Re: Response to Request for Further Information – Section 92 RMA

Application: BUN60453420 (LUC60453421 and DIS60453422)

We write in response to Council's Section 92 Request for Further Information (dated 13 August 2025) for the above application. The following responses address items 2, 5, 6, 7, 8, 11, and 16–20 of the request.

DWG Erosion and Sediment Control Plan

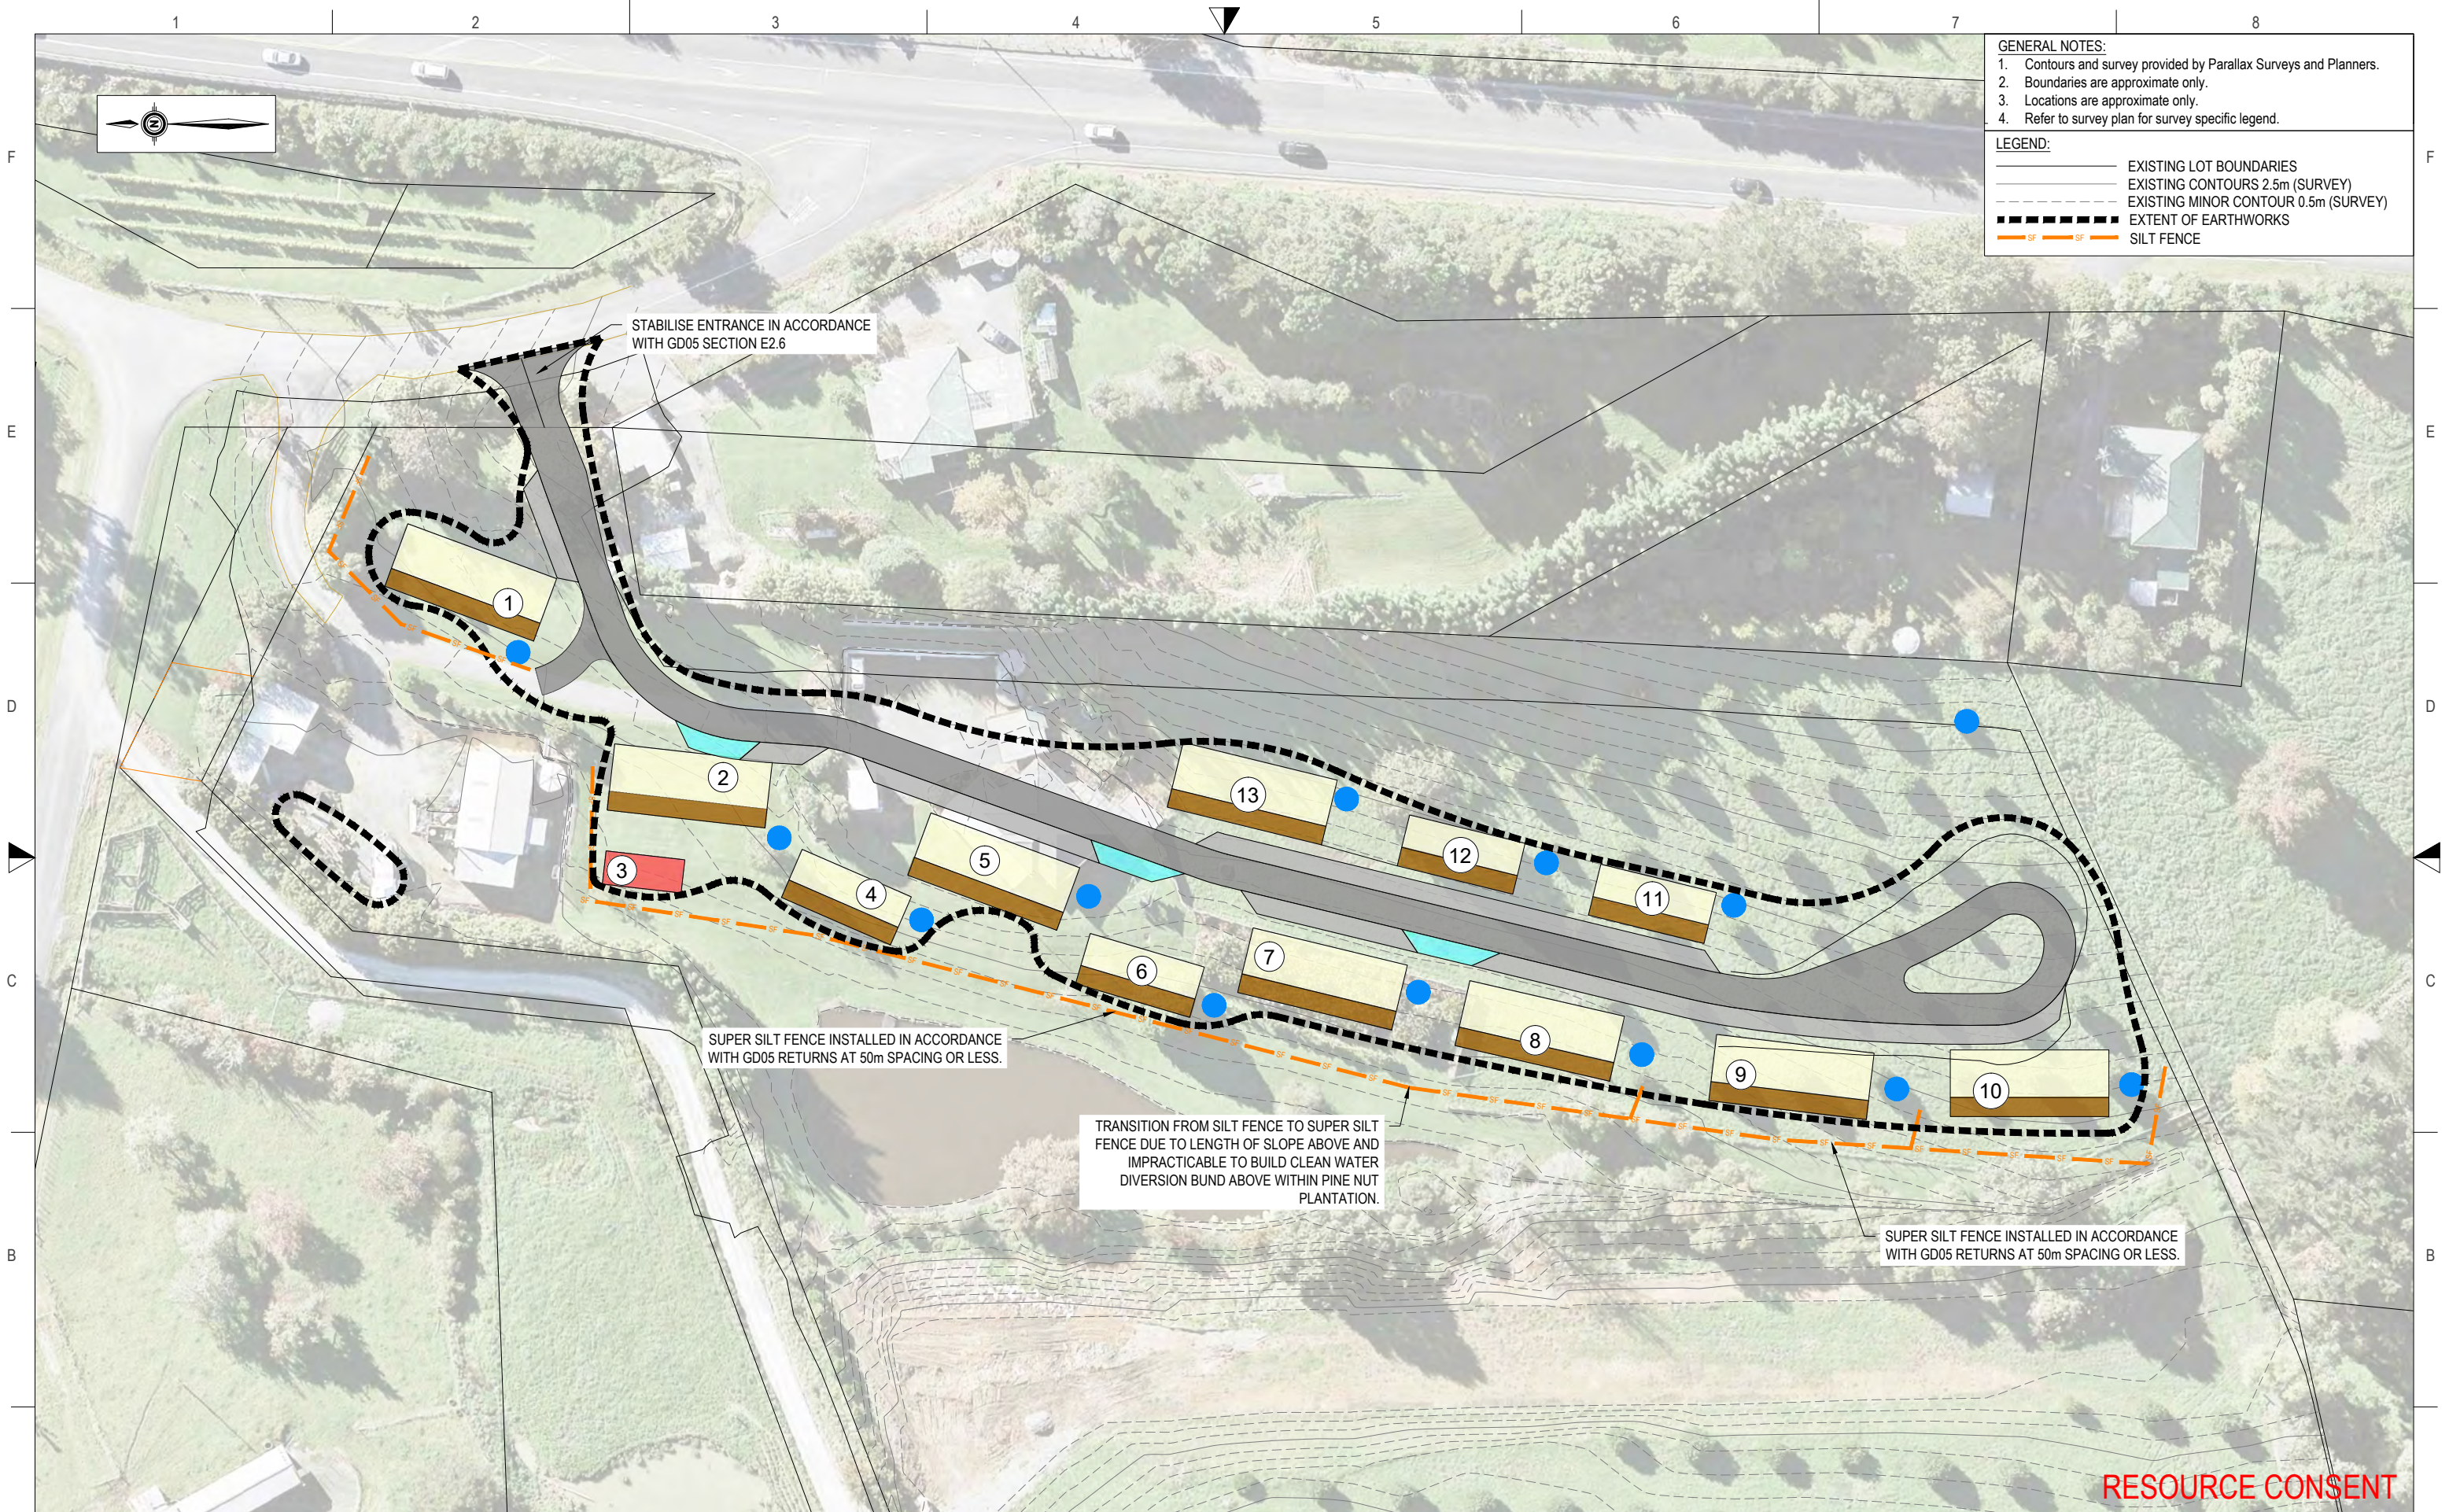
Q2. An erosion and sediment control plan has been noted within the submitted AEE as having been prepared, however, it cannot be located in the application documents. Please provide this.

An Erosion and Sediment Control Plan (ESCP) has been prepared in accordance with Auckland Council's GD05 guidelines. The plan includes silt fencing and super silt fencing where required. A clean water diversion bund has been considered as not suitable where catchment slopes exceed 50m in length as the effects of constructing a diversion bund through the existing pine nut trees for a short construction period is not suitable.

The ESCP is provided on drawing ESCP-01 in Appendix A.
